# Declaration

Model Information:	
Applicant's Name:	BYD Precision Manufacture Co., Ltd.
Applicant's Business Address:	No.3001, Baohe Road, Baolong Industrial, Longgang, Shenzhen, 518116, P.R.China
Model Name:	T02D
HW version:	MP
SW version:	YTP802A110830

The main differences conducted to 2nd source as below:

Hardware change history is list below

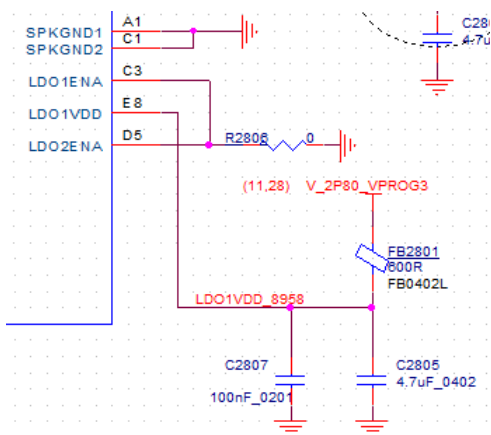
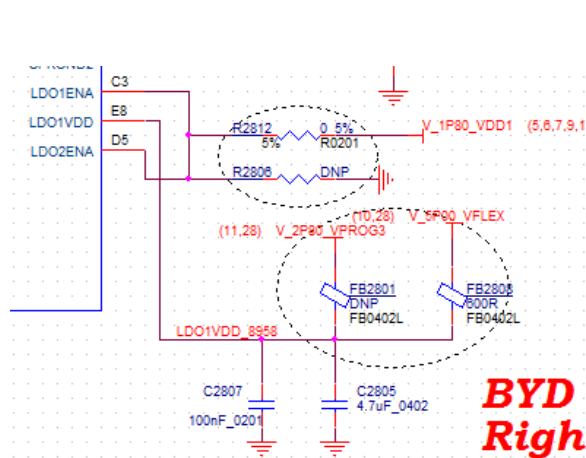
## 1、AVDD1&DCVDD Changed to internal LDO to improve power consumption and resolve earphone detect issue.

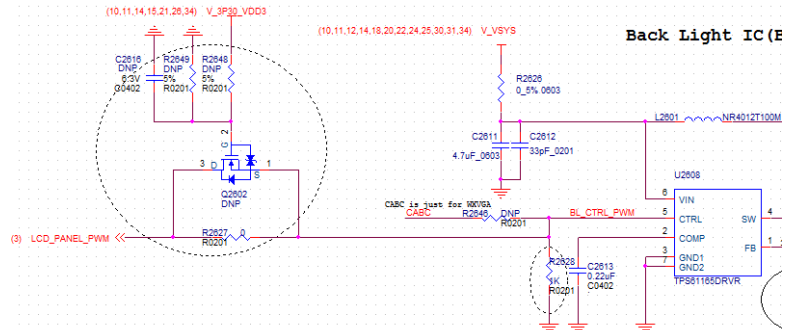
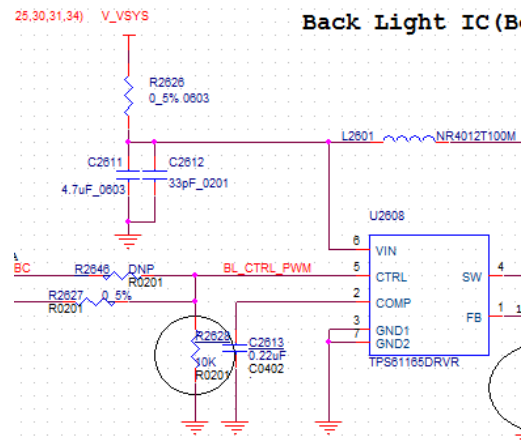
2、 Change R2628 from 10K to 1K for LCD flicker while power on. And add reserve circuit to avoid LCD flick issue if the current solution is not OK.

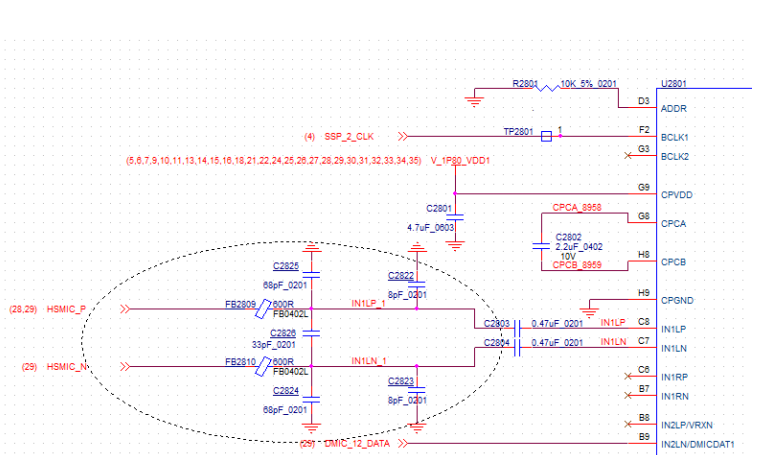
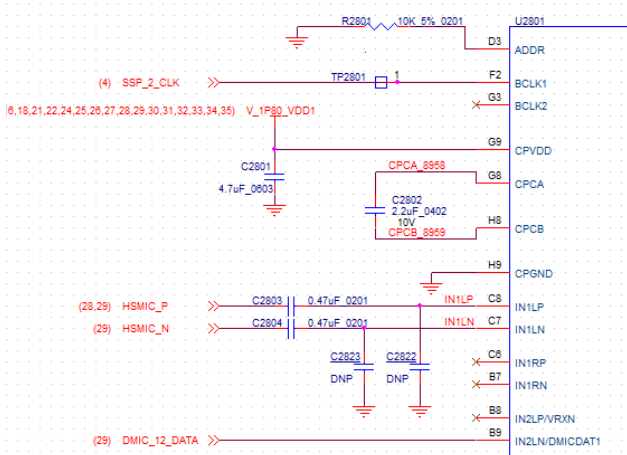
3、 ADD C2822,C2823,C2824,C2825,C2826,FB2809,FB2810 to filter TDMA Noise.

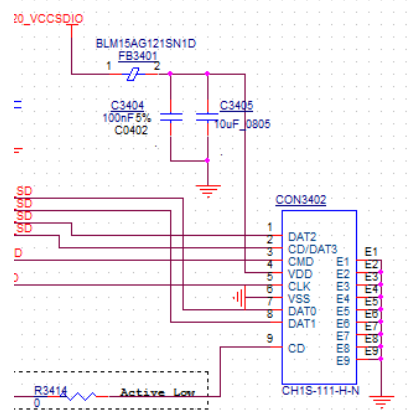
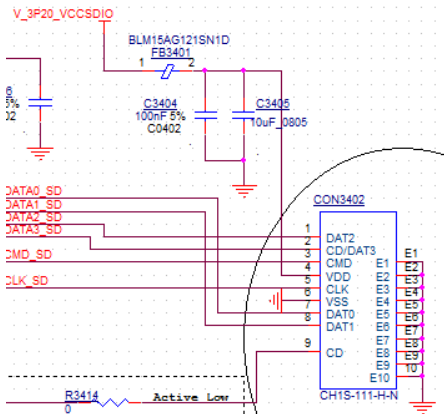
4、 Delete pin E10, because this pin is easily short to SD card's frame GND and after del E10 pin it will not influence the reliability.

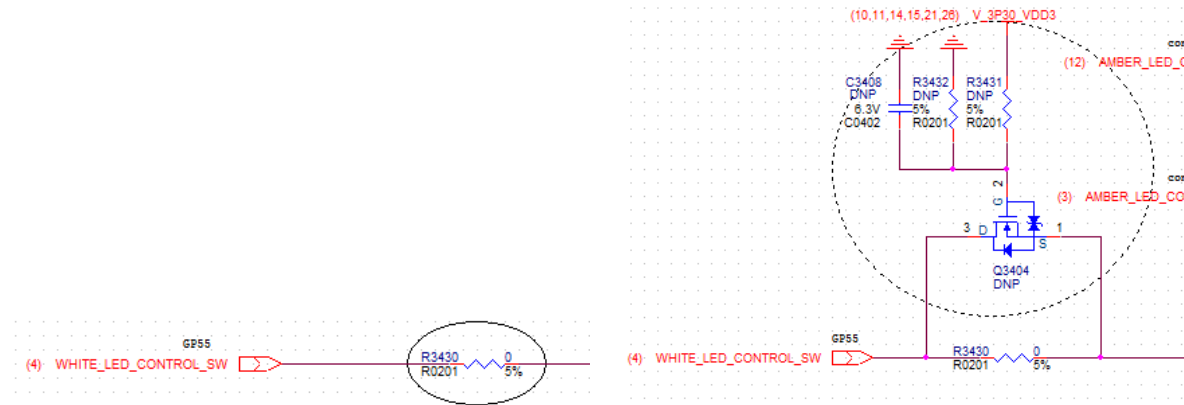
5、Reserve a circuit to solve LED blink when press power button to power on issue.
